SERVICE BULLETIN

INSPECTION OF SLINGSBY T67 FIREFLY AIRCRAFT FOR FITTING OF UNDERCUT BOLTS

Figure 1

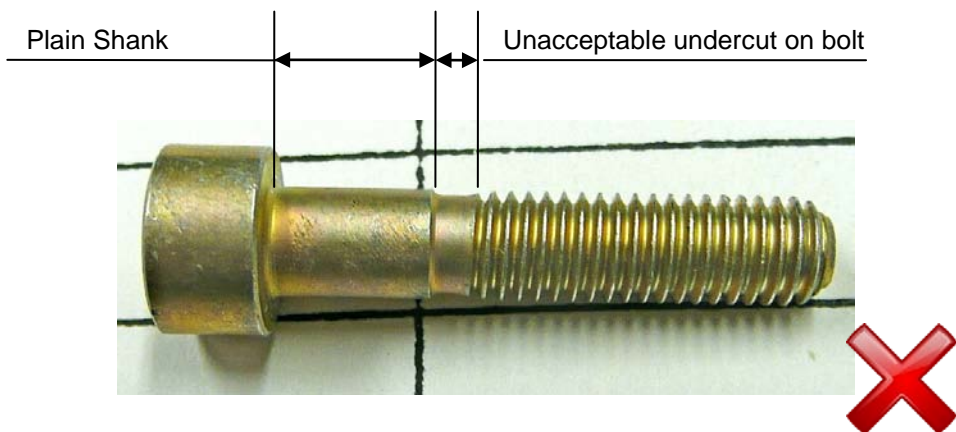
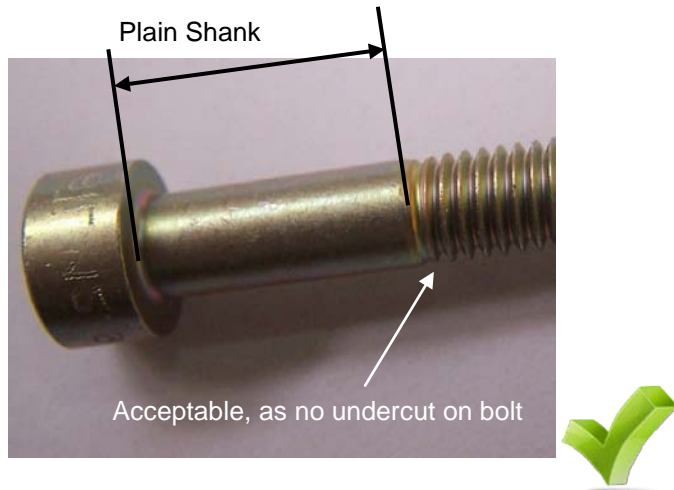
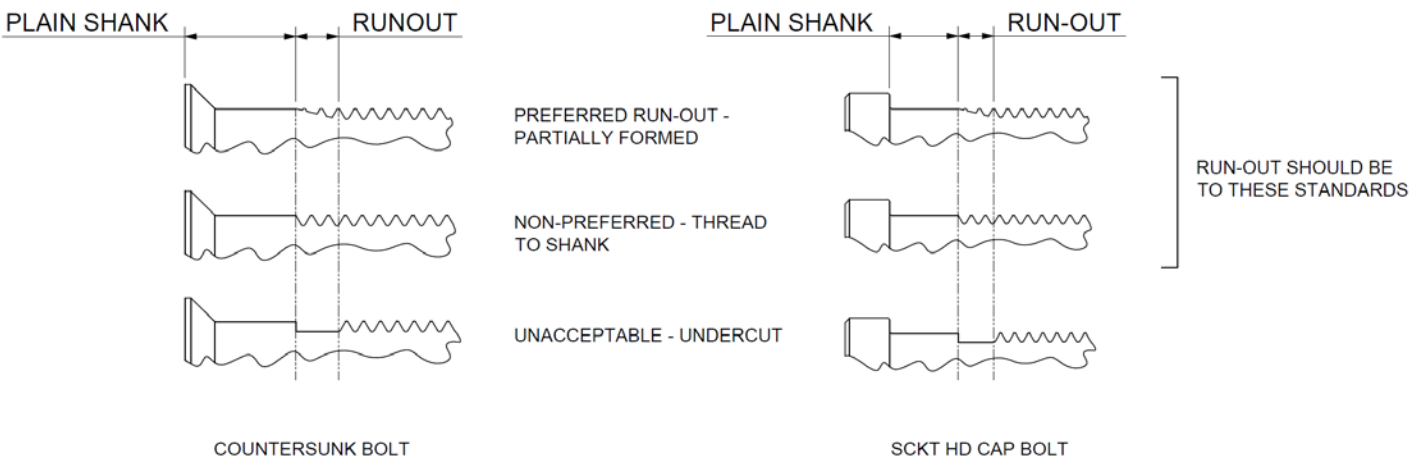
**ACCEPTABLE AND UNACCEPTABLE BOLTS. FOR GUIDANCE DURING BOLT INSPECTION.
REFER TO SECTION 3, PARAGRAPH D, PART A AND B STEP 2.**

**Figure 2 - Engine mounting frame on T67
From IPC Firefly T67, Chapter 15, Figure 4**

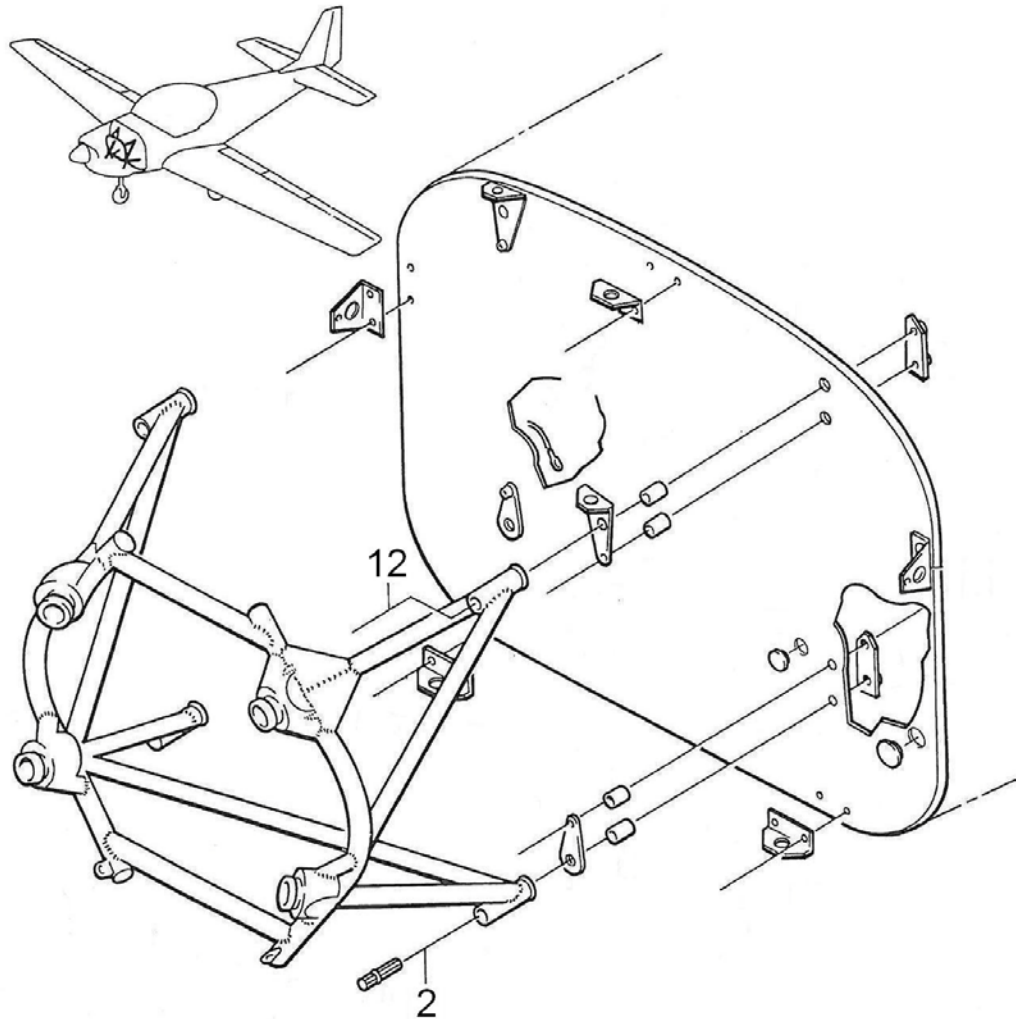
EXPLODED VIEW OF ENGINE MOUNTING FRAME, INDICATING BOLTS WHICH REQUIRE INSPECTION AS PER SECTION 3, PARAGRAPH D, PART B, STEP 2. IF BOLT UNDERCUT IS IDENTIFIED, REPLACE WITH STANDARD BOLT AS INDICATED IN ABOVE TABLE.

**Figure 3 - Engine mounting frame on the T67M260 Variant
From IPC Firefly T67M260, Chapter 15, Figure 2**

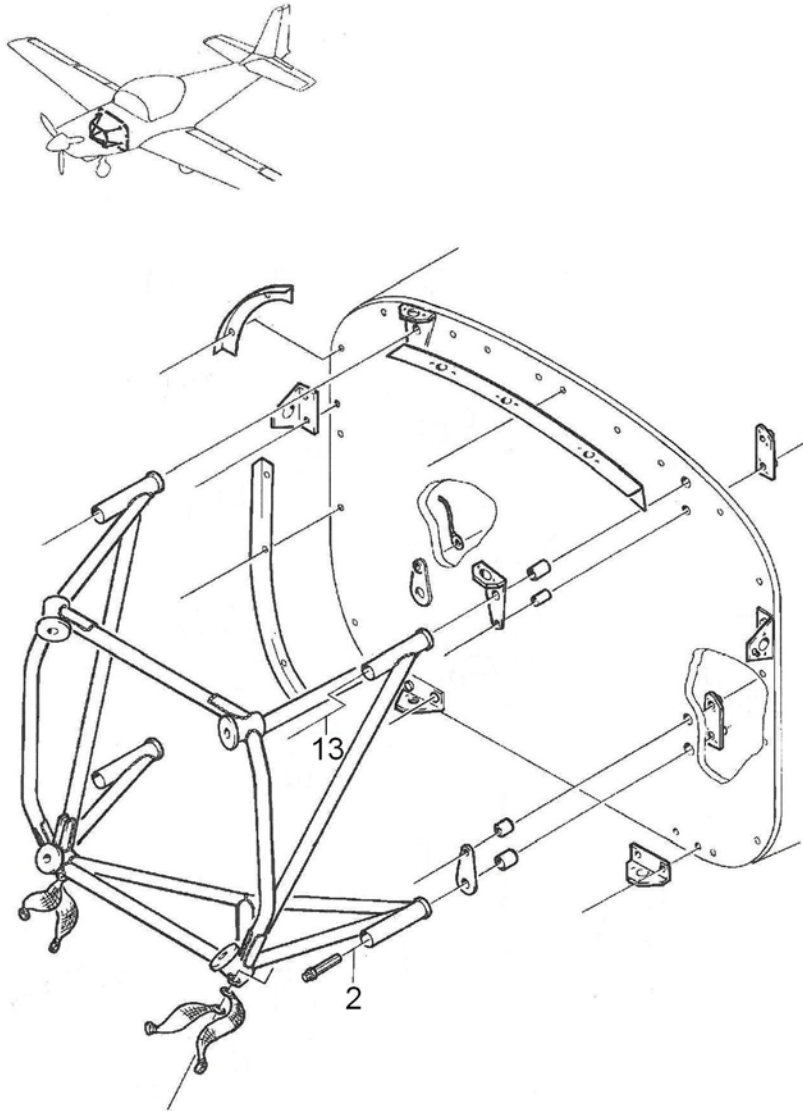
EXPLODED VIEW OF ENGINE MOUNTING FRAME ON THE T67 M260, INDICATING BOLTS WHICH REQUIRE INSPECTION AS PER SECTION 23, PARAGRAPH D, PART B, STEP 2. IF BOLT UNDERCUT IS IDENTIFIED, REPLACE WITH STANDARD BOLT AS INDICATED IN ABOVE TABLE.

**Figure 4 - Rudder lower hinge plate on T67
From IPC T67, Chapter 15, Figure 6**

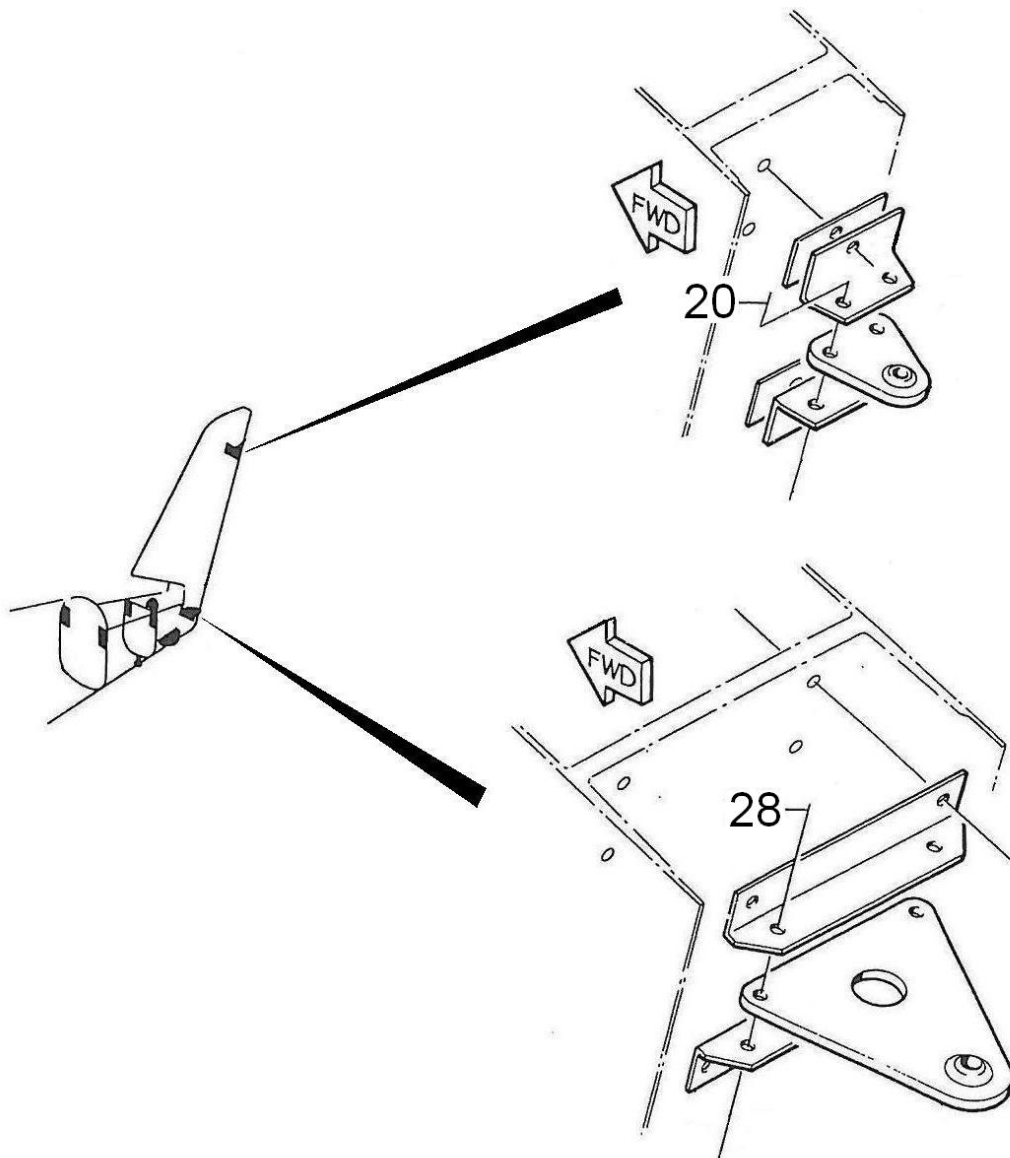
EXPLODED VIEW OF RUDDER LOWER HINGE PLATE, INDICATING BOLTS WHICH REQUIRE INSPECTION AS PER SECTION 3, PARAGRAPH D, PART B, STEP 2. IF BOLT UNDERCUT IS IDENTIFIED, REPLACE WITH STANDARD BOLT AS INDICATED IN ABOVE TABLE.

**Figure 5 - Rudder lower and upper hinge plates on T67M260 variant
From IPC T67M260, Chapter 15 Figure 4**

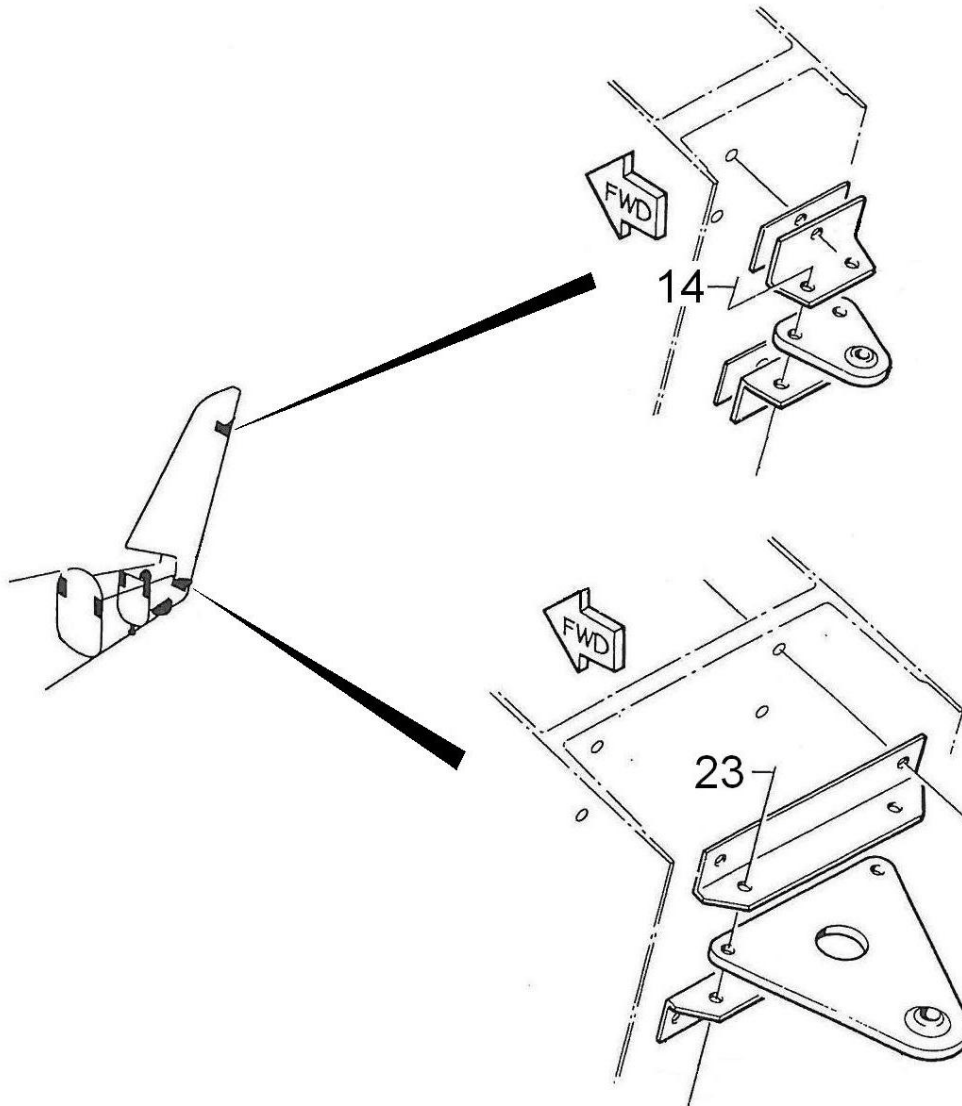
EXPLODED VIEW OF RUDDER LOWER AND UPPER HINGE PLATE, INDICATING BOLTS WHICH REQUIRE INSPECTION AS PER SECTION 3, PARAGRAPH D, PART B, STEP 2. IF BOLT UNDERCUT IS IDENTIFIED, REPLACE WITH STANDARD BOLT AS INDICATED IN ABOVE TABLE

**Figure 6 - Flap centre bearing plate on T67 alongside its location within both sides of the mainplane
From IPC T67, Chapter 16, Figure 2**

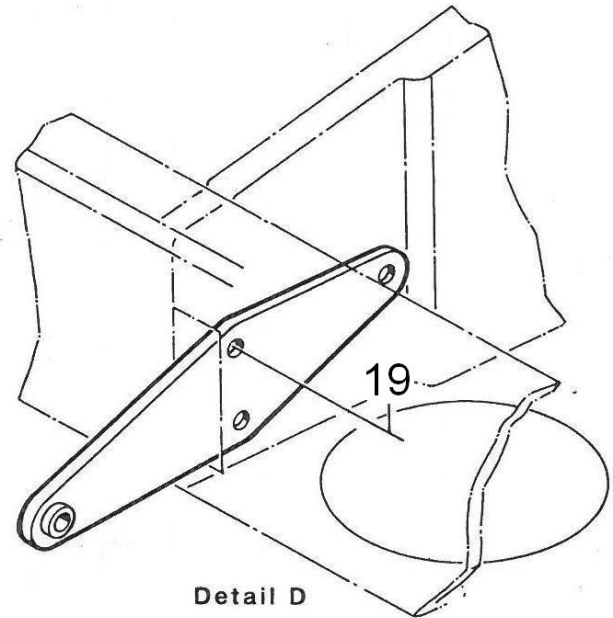
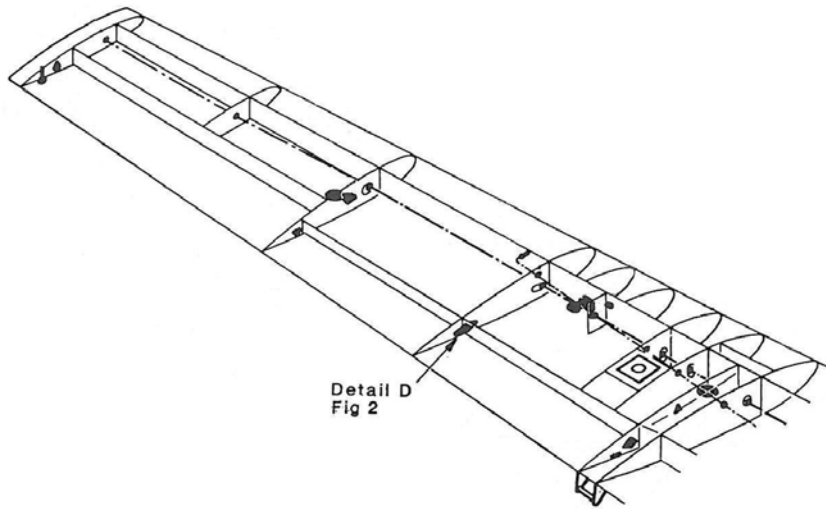
EXPLODED VIEW OF THE FLAP CENTRE BEARING PLATE, INDICATING BOLTS WHICH REQUIRE INSPECTIONS AS PER SECTION 3, PARAGRAPH D, PART B, STEP 2. IF BOLT UNDERCUT IS IDENTIFIED, REPLACE WITH STANDARD BOLT AS INDICATED IN ABOVE TABLE.

**Figure 7 - Flap centre bearing plate on the T67M260 variant alongside its location within both sides of the mainplane
From IPC T67M260, Chapter 16, Figure 2**

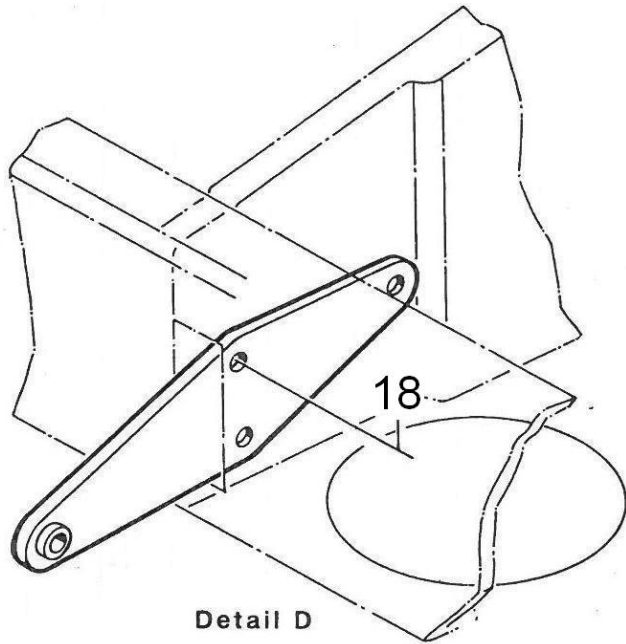
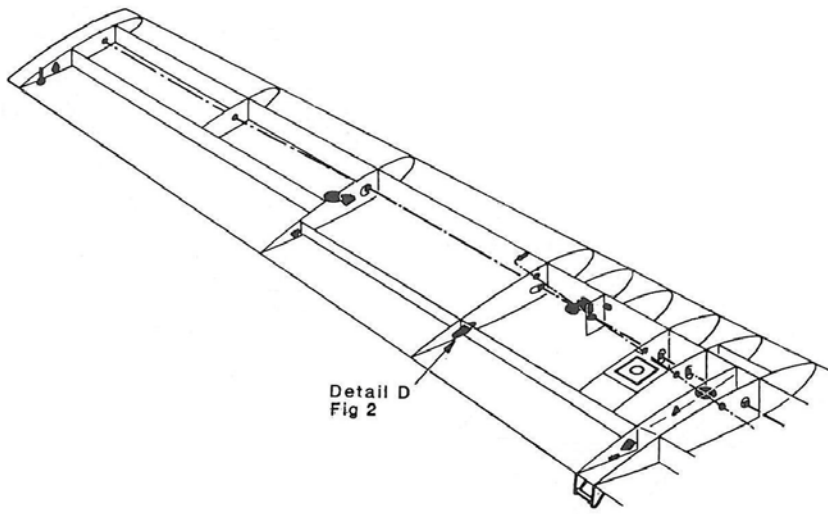
EXPLODED VIEW OF THE FLAP CENTRE BEARING PLATE, INDICATING BOLTS WHICH REQUIRE INSPECTIONS AS PER SECTION 3, PARAGRAPH D, PART B, STEP 2. IF BOLT UNDERCUT IS IDENTIFIED, REPLACE WITH STANDARD BOLT AS INDICATED IN ABOVE TABLE.

**Figure 8 - Central elevator hinge bracket and tailplane forward location bracket on T67
From IPC T67, Chapter 17, Figure2**

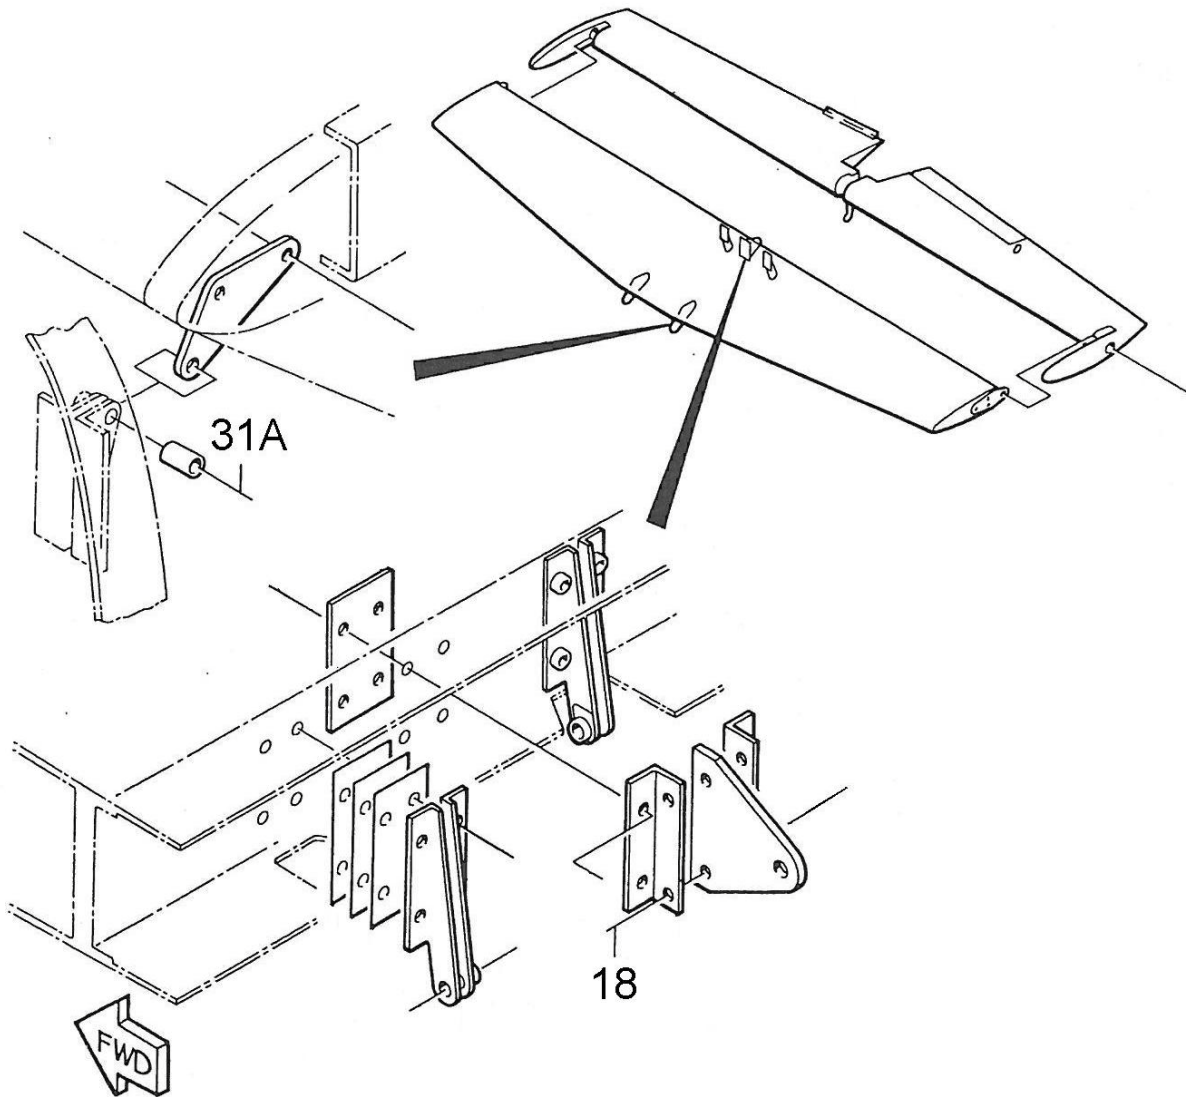
EXPLODED VIEW OF THE CENTRAL ELEVATOR HINGE PLATE AND TAILPLANE FORWARD LOCATION BRACKET, INDICATING BOLTS WHICH REQUIRE INSPECTIONS AS PER SECTION 3, PARAGRAPH D, PART B, STEP 2. IF BOLT UNDERCUT IS IDENTIFIED, REPLACE WITH STANDARD BOLT AS INDICATED IN ABOVE TABLE.

Figure 9 - Central elevator hinge bracket and tailplane forward location bracket on T67M260 variant

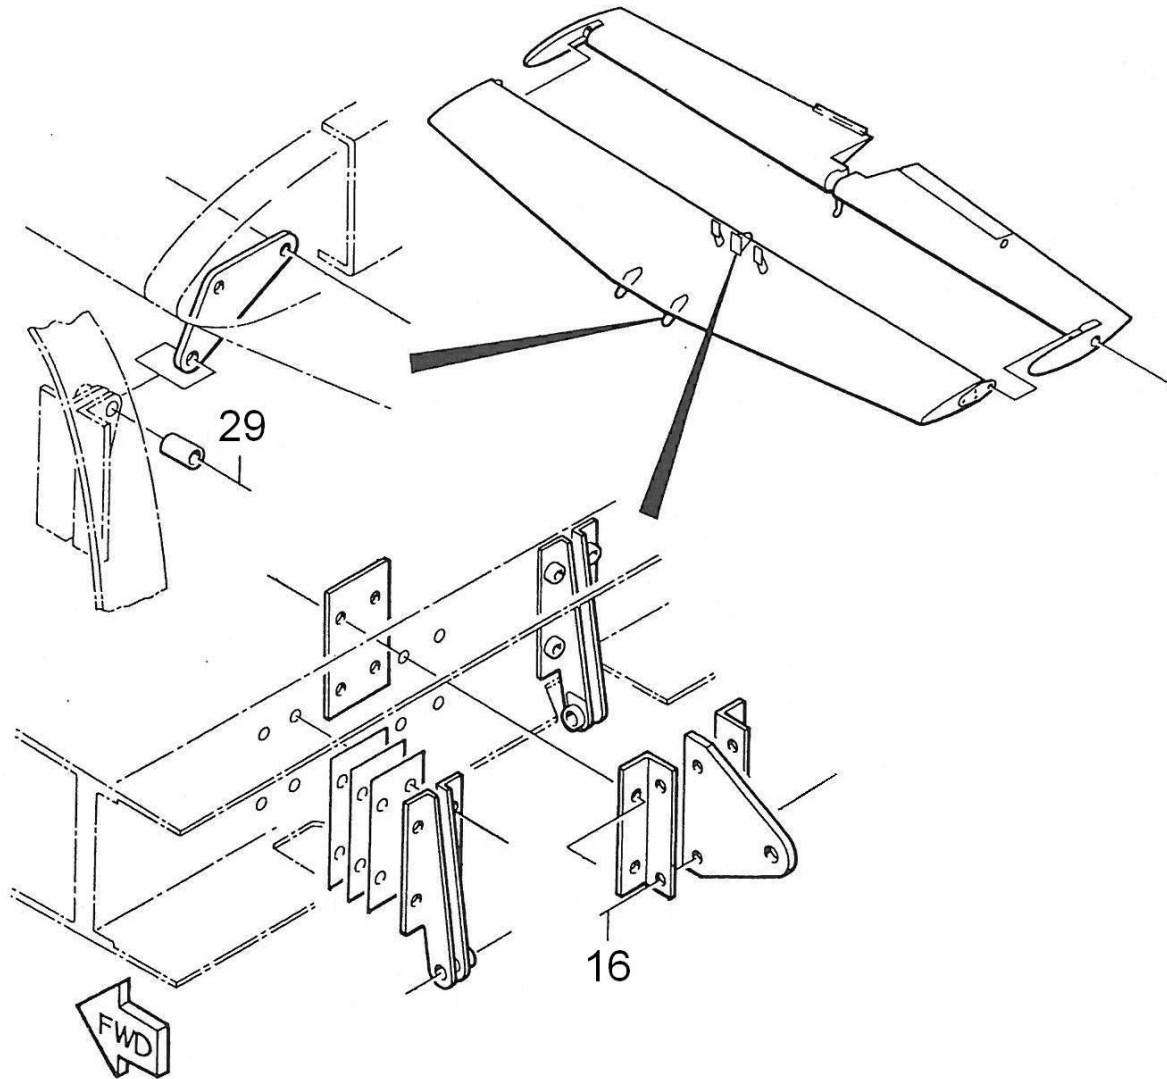
EXPLODED VIEW OF THE CENTRAL ELEVATOR HINGE PLATE AND TAILPLANE FORWARD LOCATION BRACKET, INDICATING BOLTS WHICH REQUIRE INSPECTIONS AS PER SECTION 3, PARAGRAPH D, PART B, STEP 2. IF BOLT UNDERCUT IS IDENTIFIED, REPLACE WITH STANDARD BOLT AS INDICATED IN ABOVE TABLE.

**Figure 10 - Aileron pin support plate on T67
From IPC T67, Chapter 16, Figure 1**

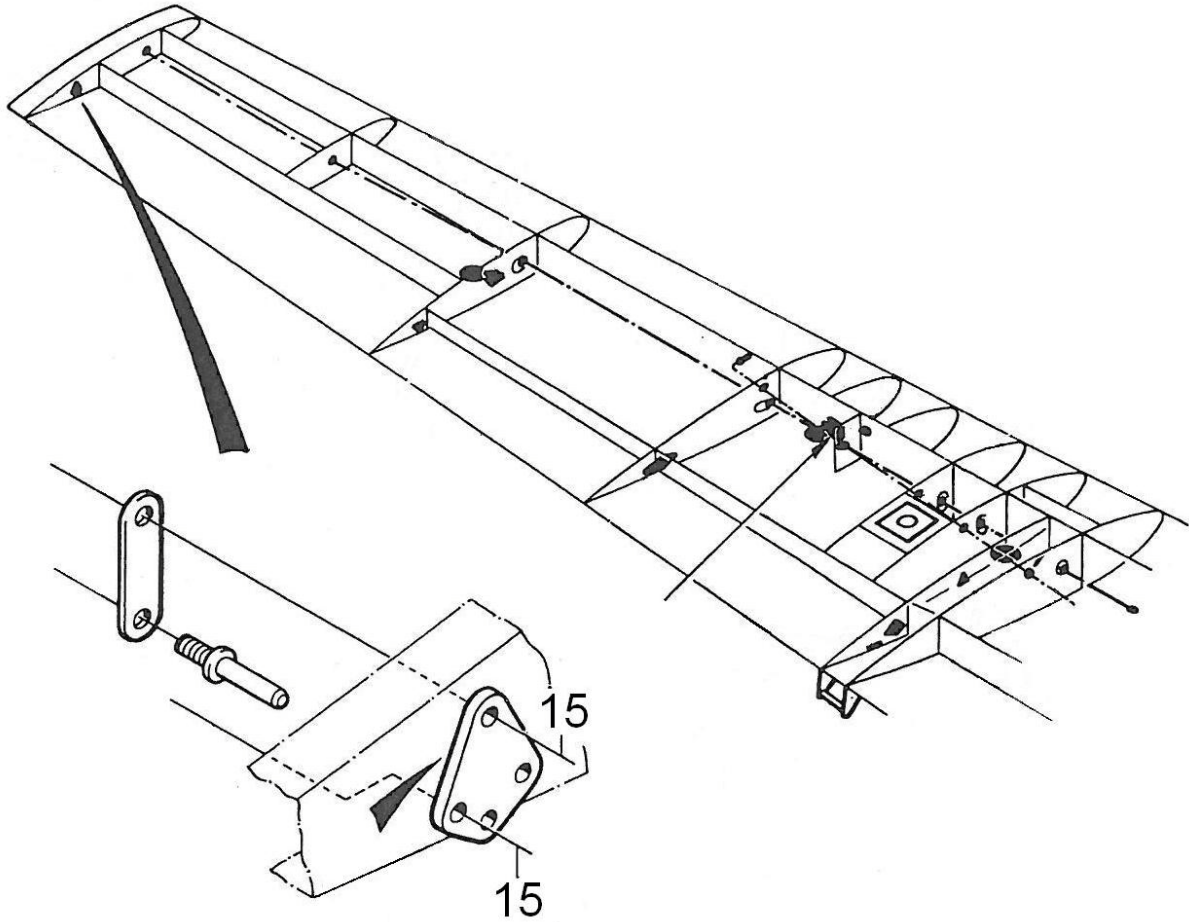
EXPLODED VIEW OF THE AILERON PIN SUPPORT PLATE, INDICATING BOLTS WHICH REQUIRE INSPECTIONS AS PER SECTION 23, PARAGRAPH D, PART B, STEP 2. IF BOLT UNDERCUT IS IDENTIFIED, REPLACE WITH STANDARD BOLT AS INDICATED IN ABOVE TABLE.
